Approved by Chair Donna Coon August 23, 2018

KEYNOTES

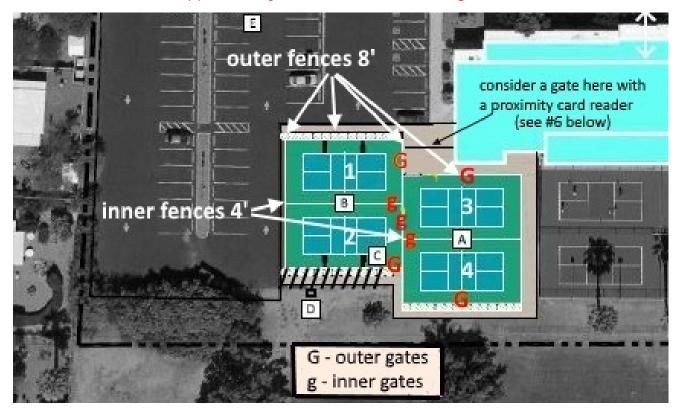
- 1) Outer fences should be 8', that includes the fence between 1-2 and 3-4.
- 2) Each court should have it's own entrance (all exterior gates should swing inward)
- 3) Inner gates are mainly for instructors that go from court to court.
- 4) The seating area between 3-4 and the new courts would be at the lower concrete level.
- 5) The seating area on the east side of court 2 isn't necessary. Players waiting to play congregate on the porch and when a court is empty the monitor calls out the court number and they head to that court.
- 6) We should consider putting a fence here with card entry, adding card entry at the door from the lobby into the porch and removing the card entry on the south pool/fitness gate. Players would then use the pool restrooms.
- 7) All exterior fences should have a bottom rail. CCT didn't put them on the new courts, maybe they can reuse the ones we added later.
